Piper Aircraft Corporation

**SUBJECT:** Fuel Cell Drain Modification

**MODELS AFFECTED:** PA-24 and PA-24 "250" Comanches, Serial Numbers 24-581 to 24-3495 inclusive

Service Bulletin  
No. 216

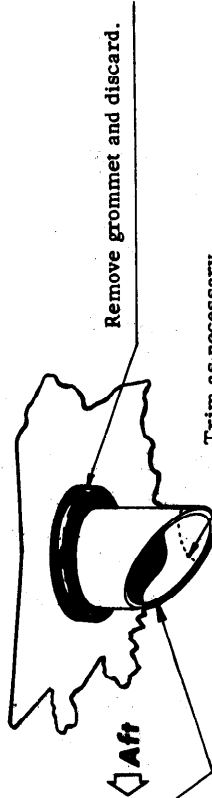
Remove grommet and discard.

Trim as necessary.

Do not enlarge hole in gasket for 1/2" tube as it will stretch over tube.
